SERVICE BULLETIN

N° 139-685

ATA 93 - AIRCRAFT SURVIVABILITY EQUIPMENT (ASE) MODIFICATION

This Service Bulletin is issued in order to provide the necessary instruction on how to perform the FLIR variant for kit ASE P/N 3G5311A59011 and the ASE complete provision P/N 3G9350A08112.

Figure 6

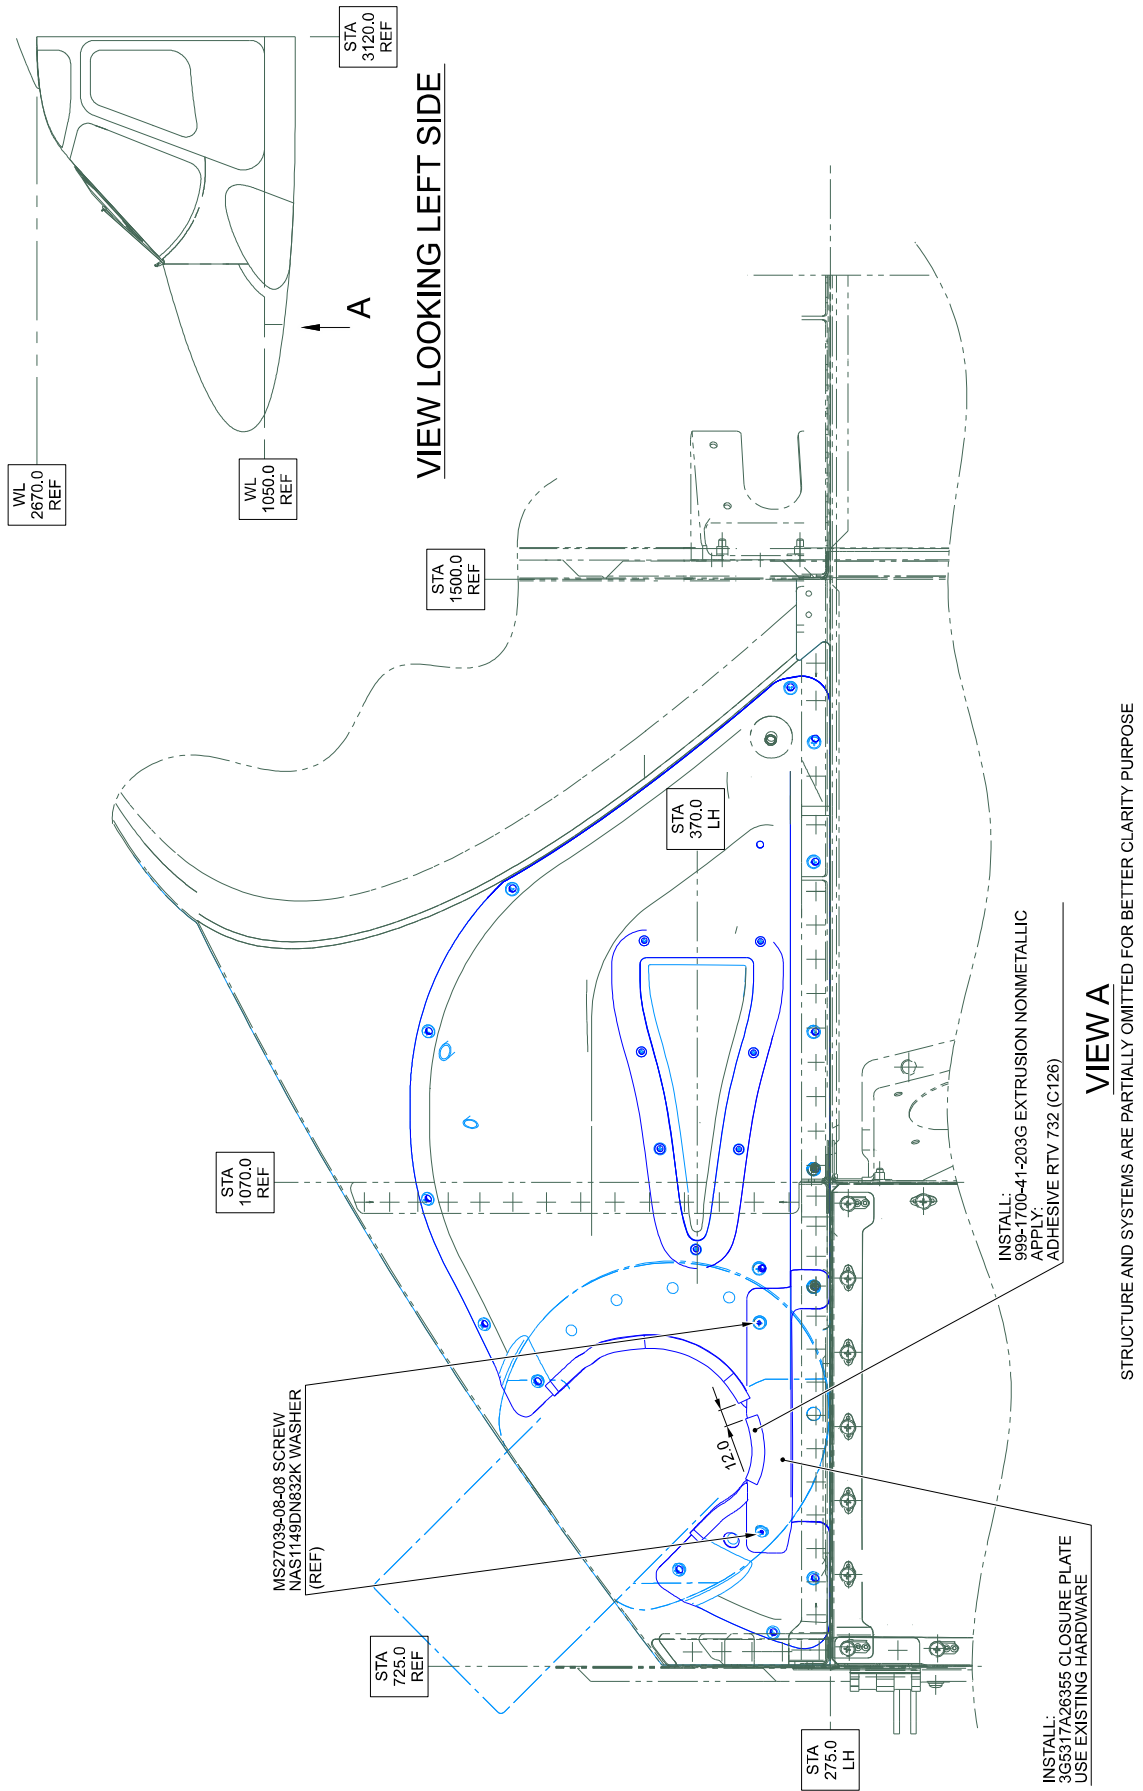
13. With reference to Figure 6, perform the closure plate variant for ASE P/N 3G5311A58811 as described in the following procedure:
 - 13.1 With reference to Figure 6 View A, install the extrusion non-metallic P/N 999-1700-41-203G (length 55.0 mm) on the edge of the closure plate P/N 3G5317A26355 in accordance with the dimension shown by means of the adhesive RTV 732 (C126).
 - 13.2 With reference to Figure 6 View A, install the closure plate P/N 3G5317A26355 on the FWD and AFT cable covers assy by means of existing hardware previously

Figure 7

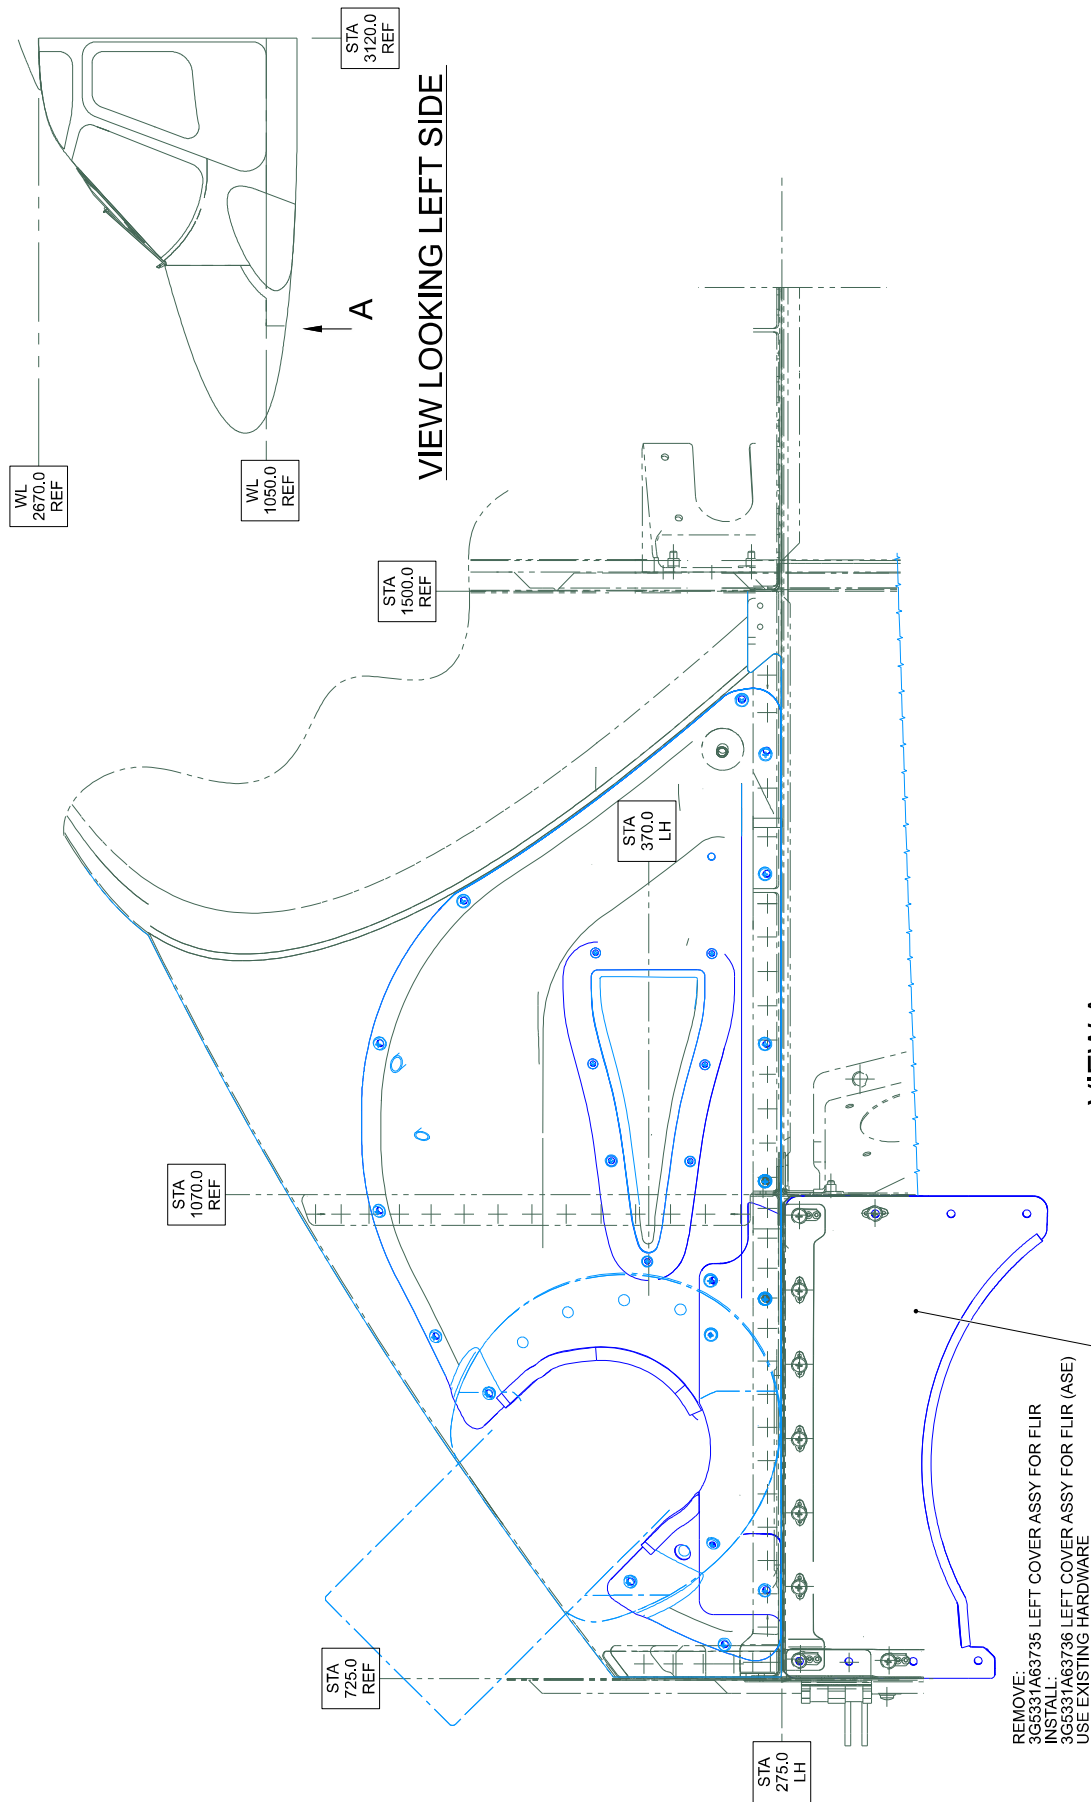
14. With reference to Figure 7 View A, perform the left cover assy variant for ASE P/N 3G5311A58911 and install the left cover assy for FLIR (ASE) P/N 3G5331A63736 by means of existing hardware previously removed at step 3.

Figure 8

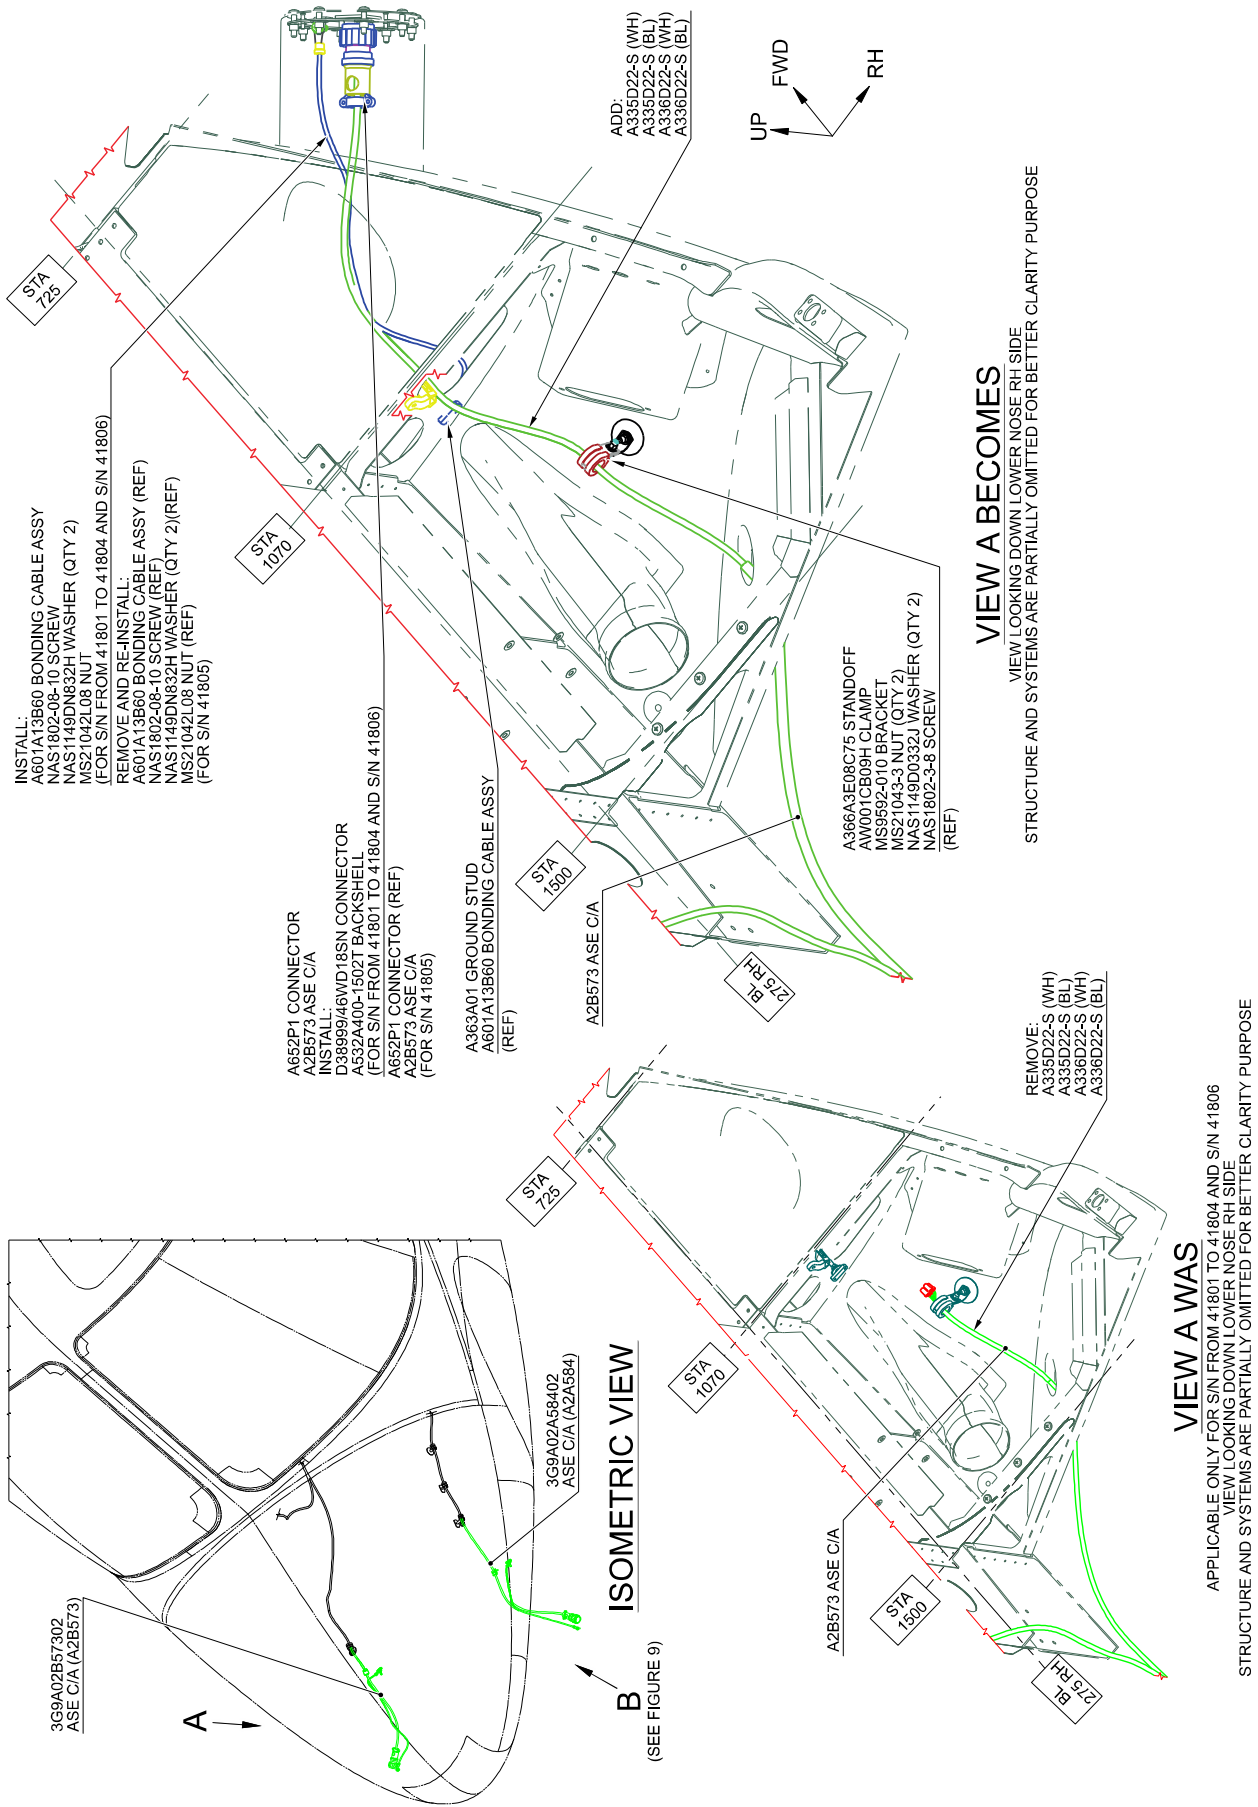
15.6.1 With reference to Figure 8 View A Becomes and Figure 12 Wiring Diagram, assemble the connector A652P1 by means of the electrical connector P/N D38999/46WD18SN and the backshell P/N A532A400-1502T.

15.6.2 With reference to Figure 8 View A Was and Figure 12 Wiring Diagram, remove the wires marked as A335D22-S (WH and BL).

- 15.6.6 In accordance with AMP DM 39-A-20-10-18-00A-691A-A and with reference to Figure 8 View A Becomes and Figure 12 Wiring diagram, mark wire as A335D22-S (WH and BL) by means of marker sleeve or laser marking.

- 15.6.10 In accordance with AMP DM 39-A-20-10-18-00A-691A-A and with reference to Figure 8 View A Becomes and Figure 12 Wiring diagram, mark wire as A336D22-S (WH and BL) by means of marker sleeve or laser marking.

Figure 9

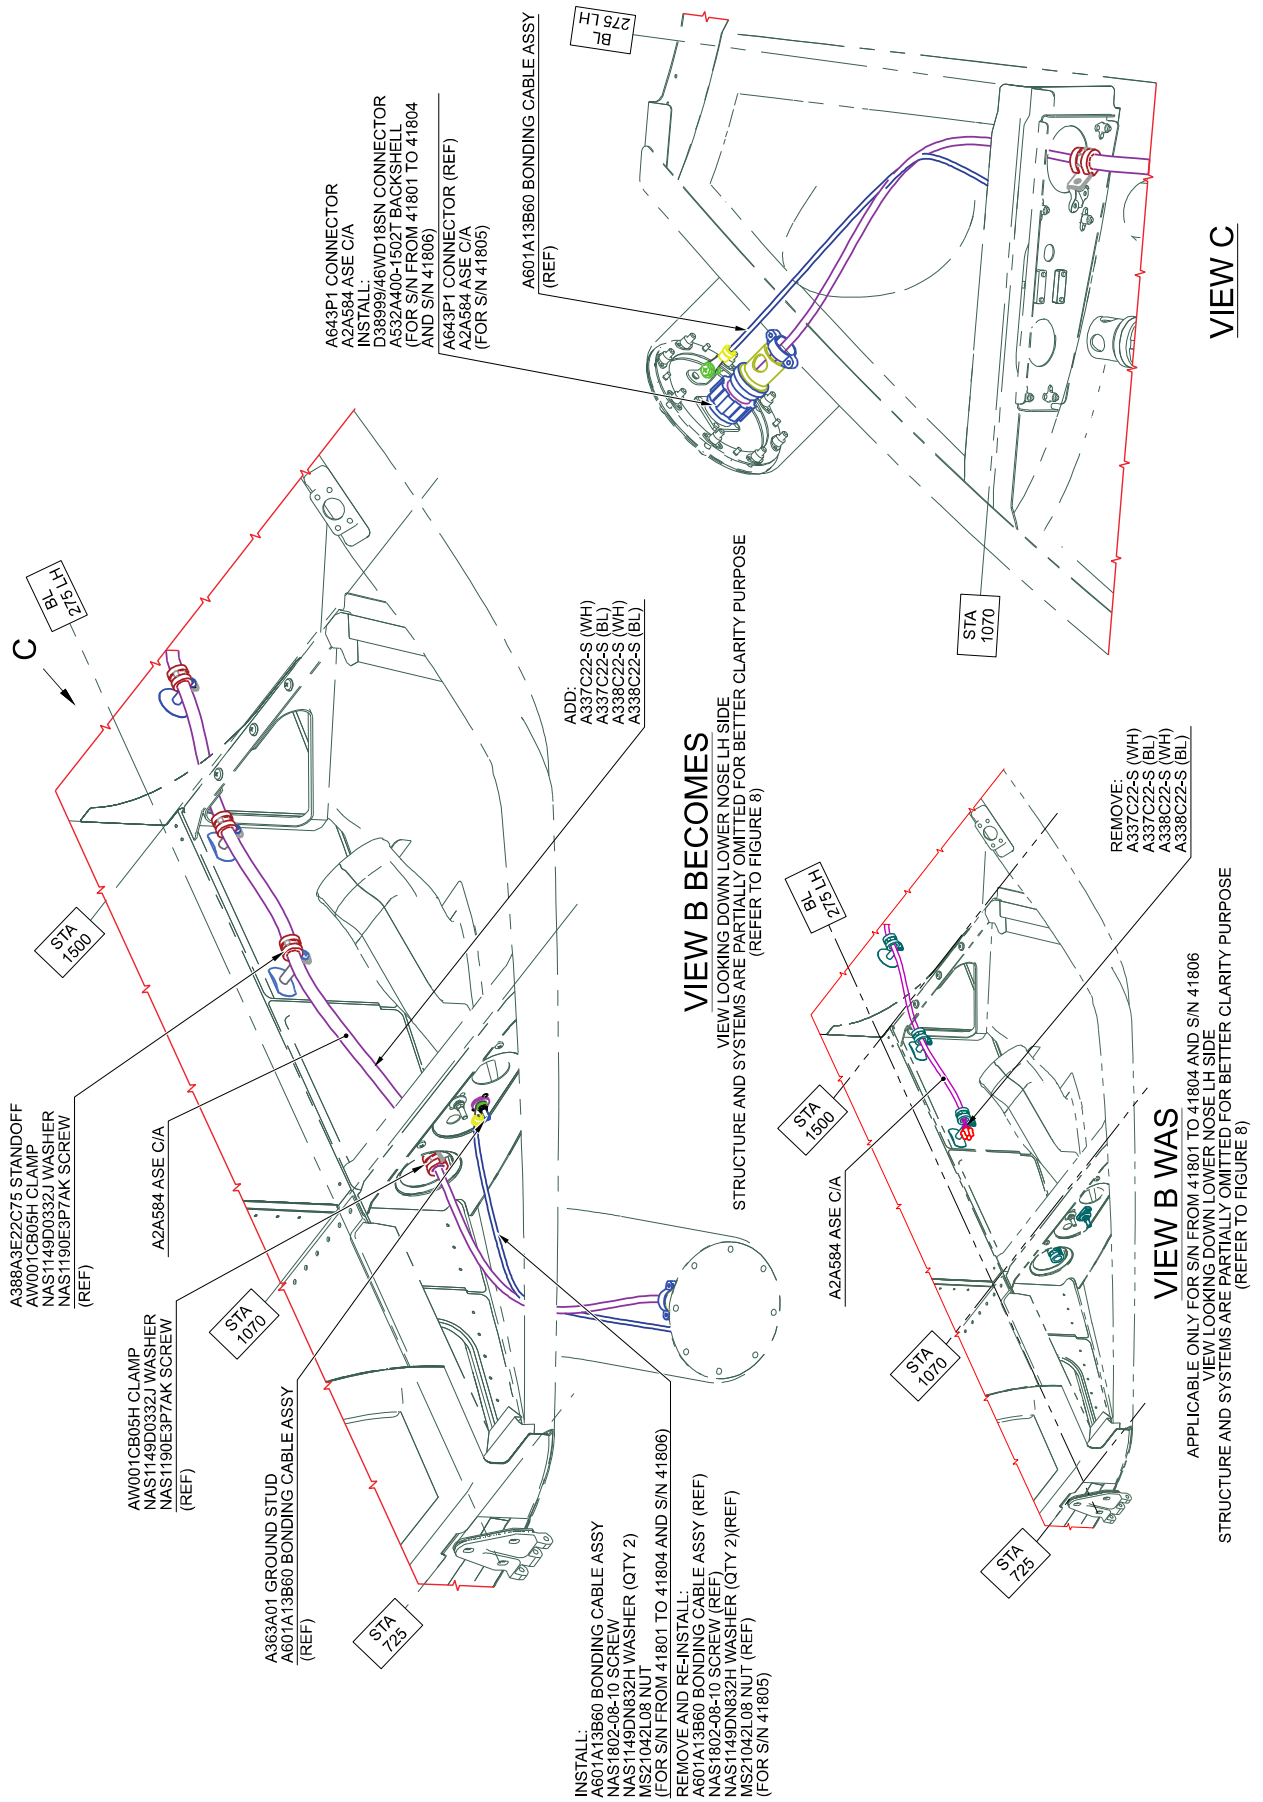
- 15.1 With reference to Figures 9 and 12, modify the ASE C/A A2A584 as described in the following procedure:
 - 15.1.1 With reference to Figure 9 View C and Figure 12 Wiring Diagram, assemble the connector A643P1 by means of the electrical connector P/N D38999/46WD18SN and the backshell P/N A532A400-1502T.

- 15.1.2 With reference to Figure 9 View B Was and Figure 12 Wiring Diagram, remove the wires marked as A337C22-S (WH and BL).
 - 15.1.3 With reference to Figure 9 View B Was and Figure 12 Wiring Diagram, remove the wires marked as A338C22-S (WH and BL).

- 15.1.6 In accordance with AMP DM 39-A-20-10-18-00A-691A-A and with reference to Figure 9 View B Becomes and Figure 12 Wiring diagram, mark wire as A337C22-S (WH and BL) by means of marker sleeve or laser marking.

- 15.1.10 In accordance with AMP DM 39-A-20-10-18-00A-691A-A and with reference to Figure 9 View B Becomes and Figure 12 Wiring diagram, mark wire as A338C22-S (WH and BL) by means of marker sleeve or laser marking.

15.4 With reference to Figure 9 View B Becomes, install the bonding cable assy P/N A601A13B60 by means of the screw P/N NAS1802-08-10, the nut P/N MS21042L08 and n°2 washers P/N NAS1149DN832H.
